Preliminary Drainage Report  
for  
**Rolling Hills Ranch PUD**  
at  
**Meridian Ranch**

EL PASO COUNTY, COLORADO

September 2019

REVISED

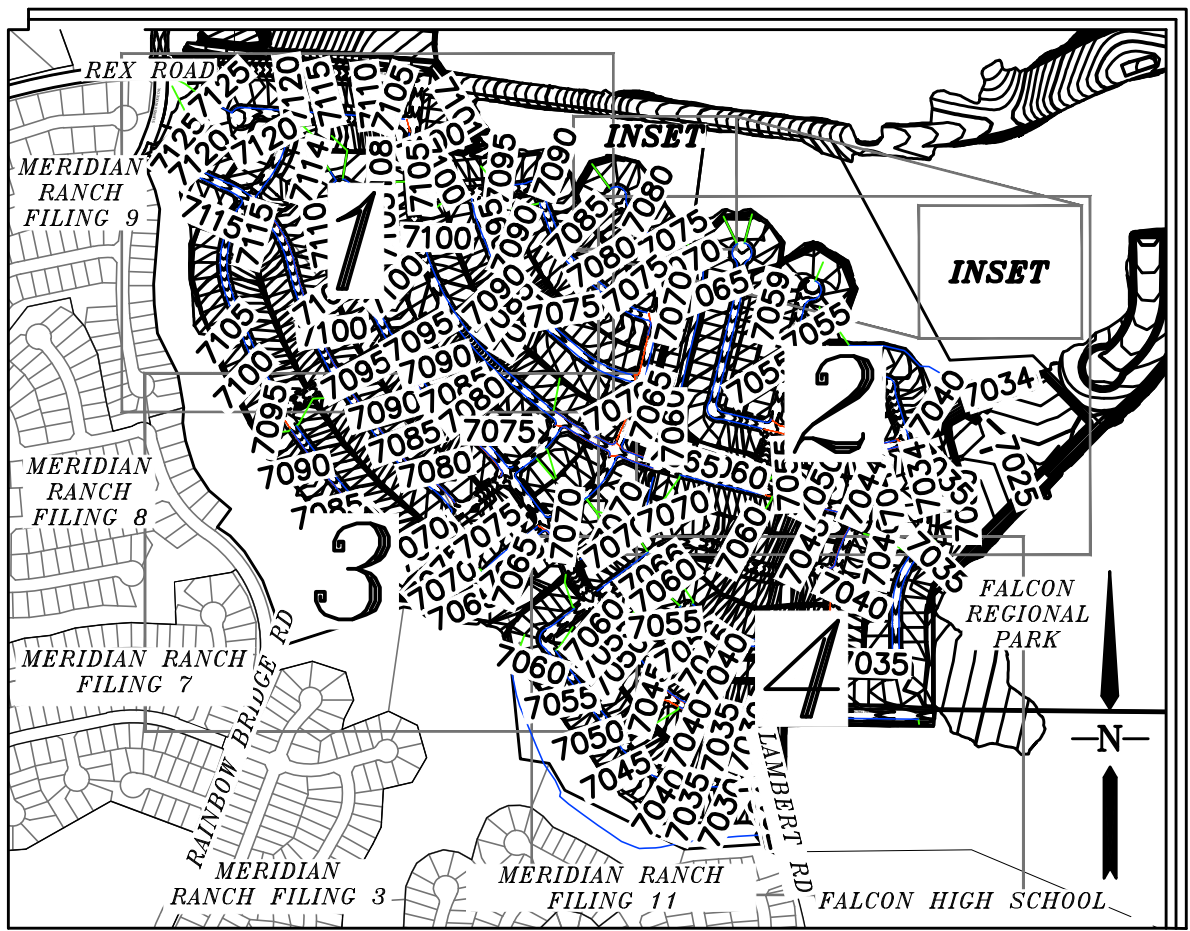
I01 missing  
REVISED

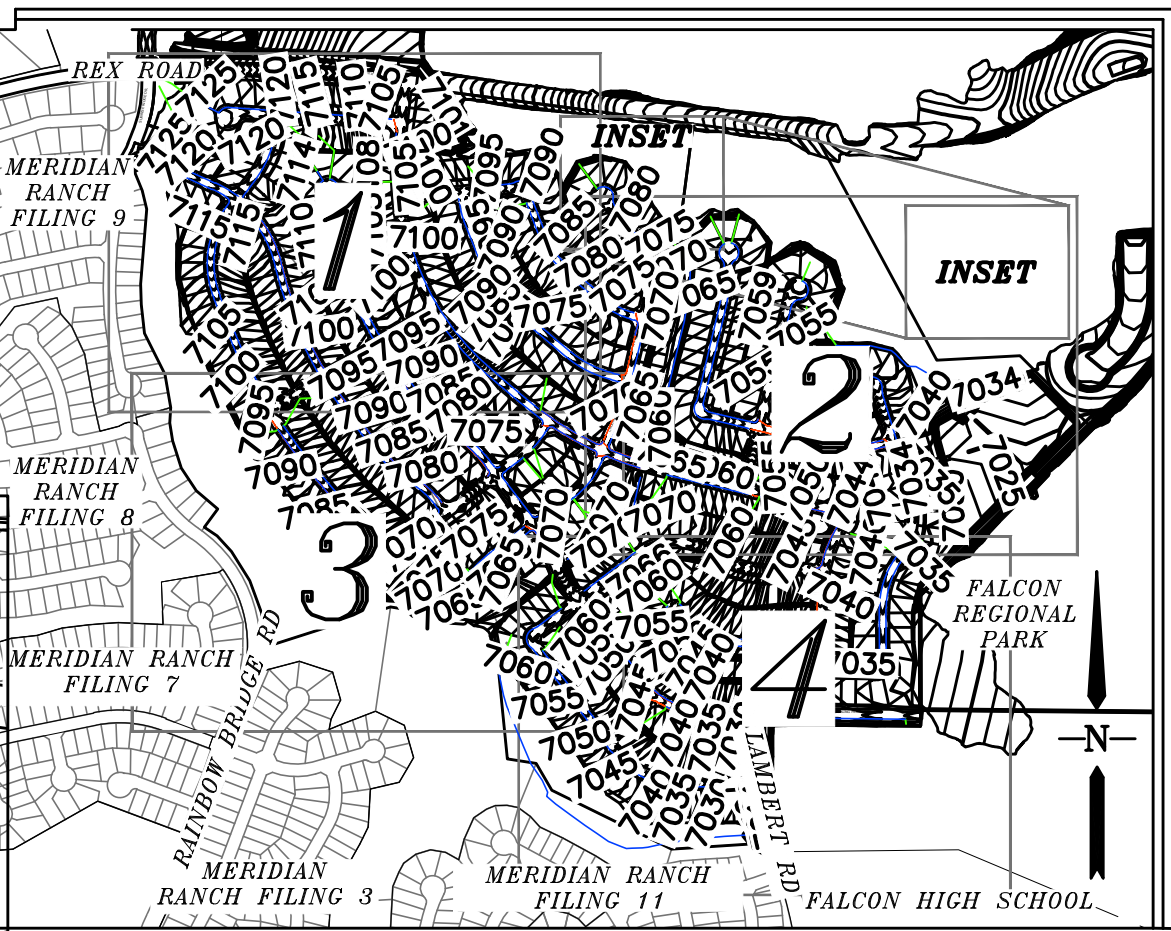
Per ECM I.7.1.C.4, Stormwater from the site must not discharge to a water of the state before being discharged to a WQCV control measure.  
WQCV required for the lots draining directly into the waters of the state.

APPLIED ECM I.7.1.C.5.,  
REGIONAL WQ FACILITY  
IS PROVIDED

RATIONAL DRAINAGE MAP  
PRELIMINARY DRAINAGE REPORT  
ROLLING HILLS RANGE

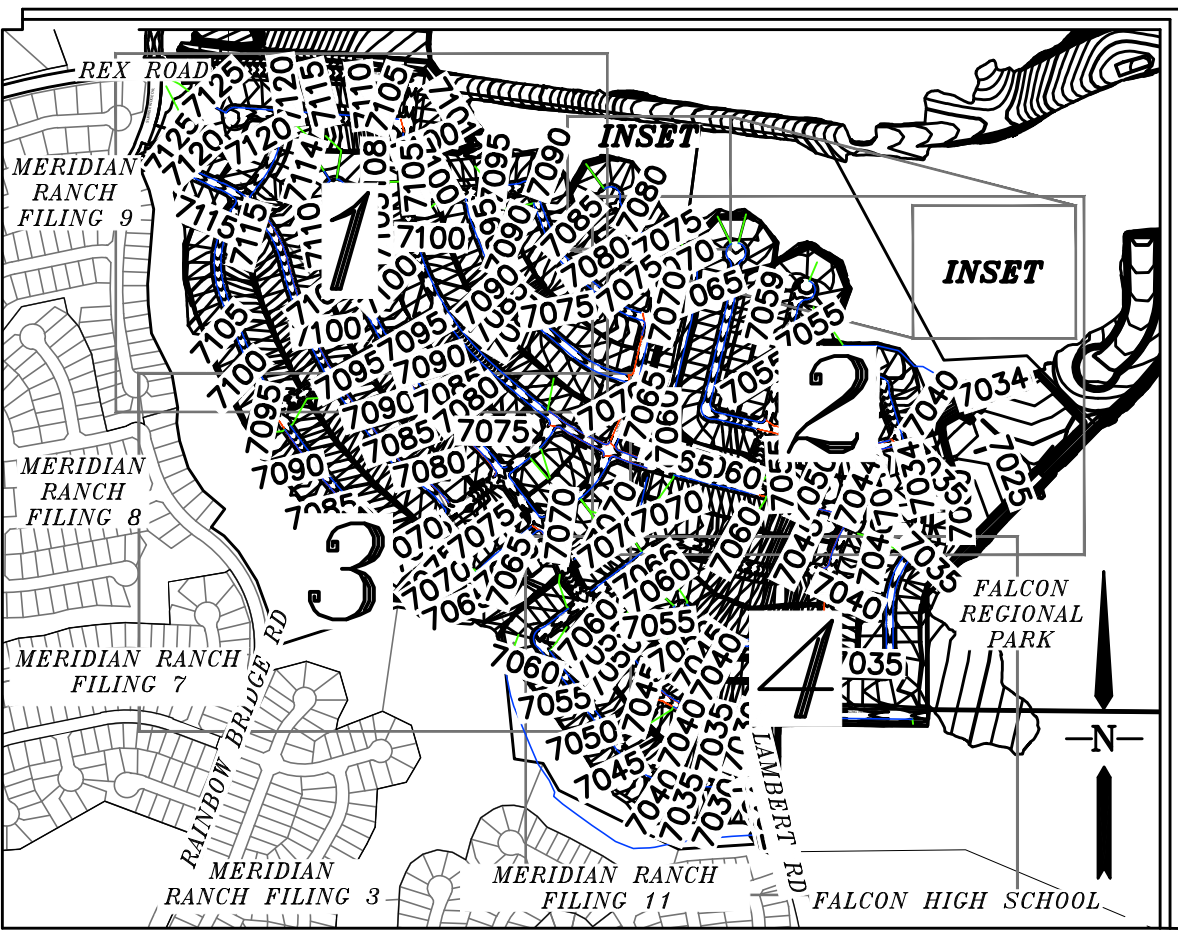
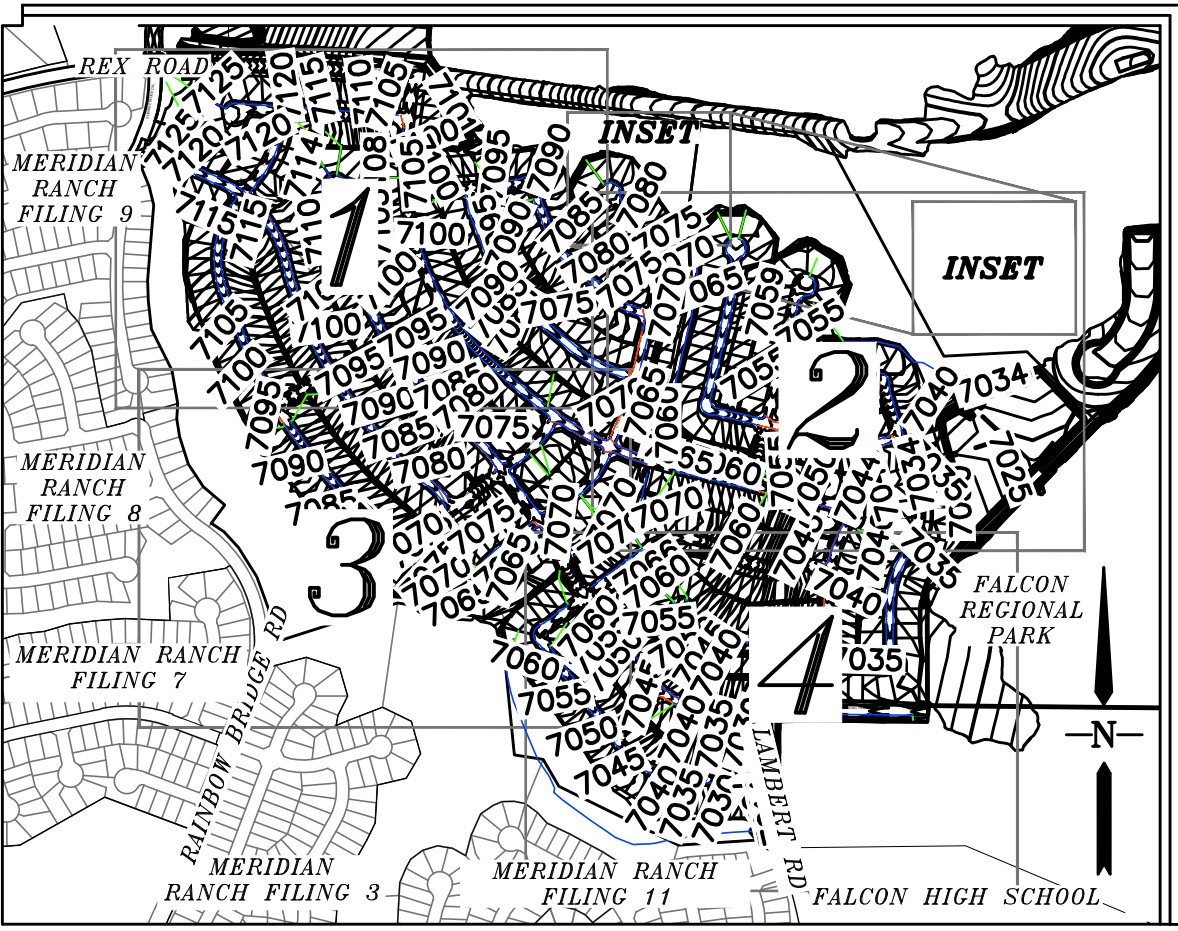
Sheet 2 and 3 viewport limits does not show the full extents of basin E11. Adjust.

REVISED
